2B	Reviewed. Comments enclosed. Incorporate the comments and re-submit for review.

TITLE - GATE				NIHVA TECHNOLOGIES PVT.LTD.PUNE
DWG NO - NTPL268-PM			QTY - 1	Website - www.nihva.com
	NAME	SIGNATURE	DATE	PROJECT NO - NTPL268-PM- AD
DRAWN	V.B.		02-05-2025	PRODUCT -SLIDING GATE
CHK'D	S.W.		02-05-2025	SITE LOCATION -
APPV'D	V.T.		02-05-2025	
if any queries contact - supportautomation@nihva.com				REVISION -00
ALL DIMENSION ARE IN mm			A3	SCALE - SHEET 1 OF 1

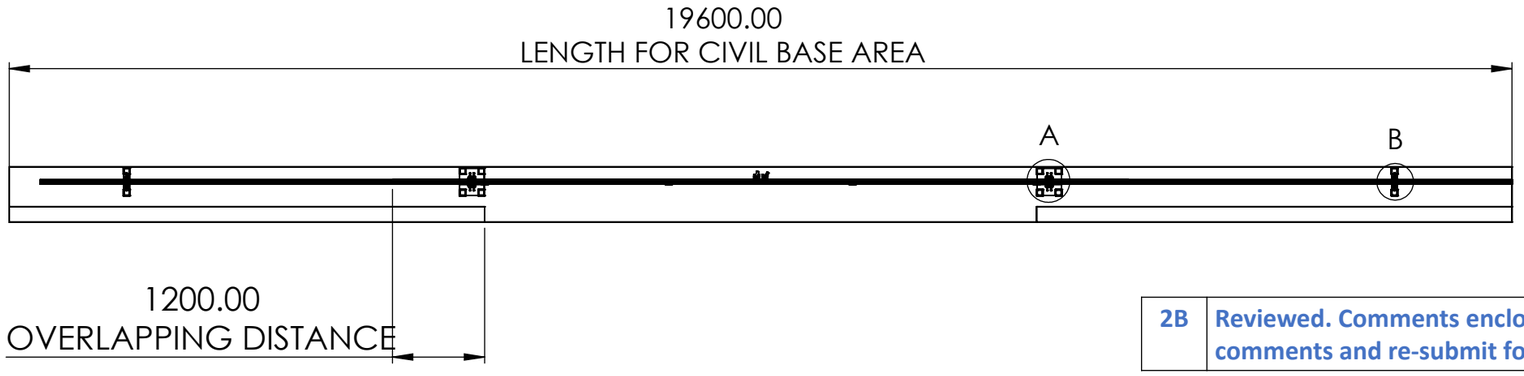
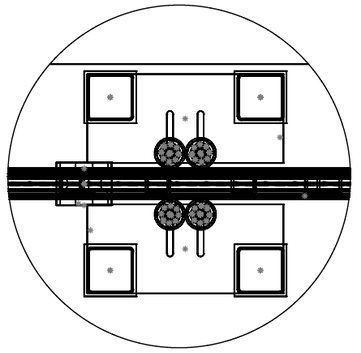
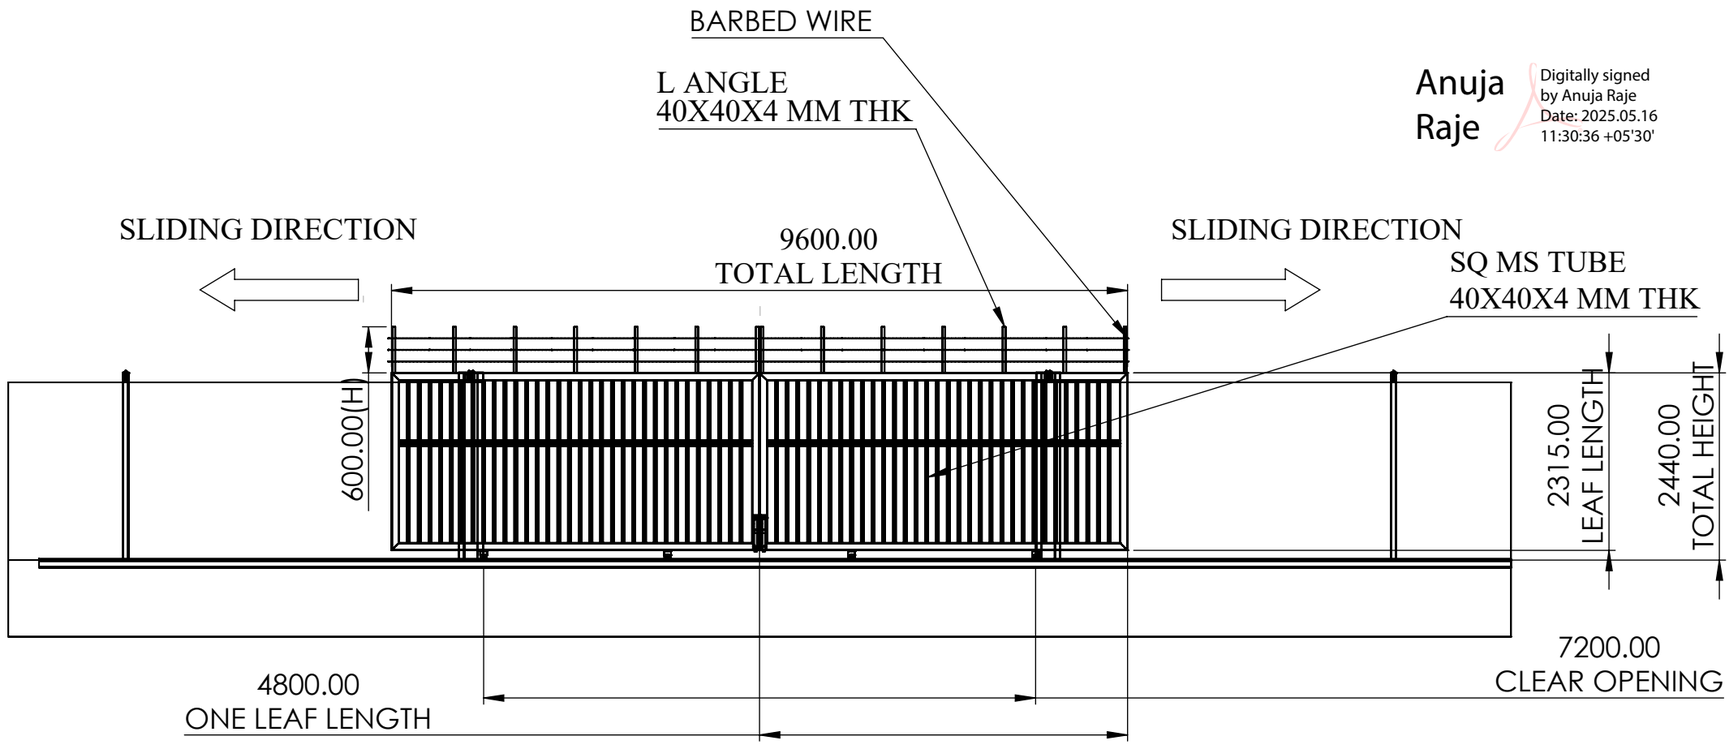
1. Please refer to the latest master layout for the exact site dimensions and space availability.
2. Barbed wire fencing above the sliding gate is under finalization with the Air India team. TCE will confirm shortly.
3. Please specify whether the elevation view is from the inside or outside. It is currently unclear.
4. As the door sizes are as per the requirement, kindly consider the weight and design the sections accordingly. Also, the wheel should be a double wheel, as shown in the architectural layout. Locking arrangement details are missing from the GA drawing.
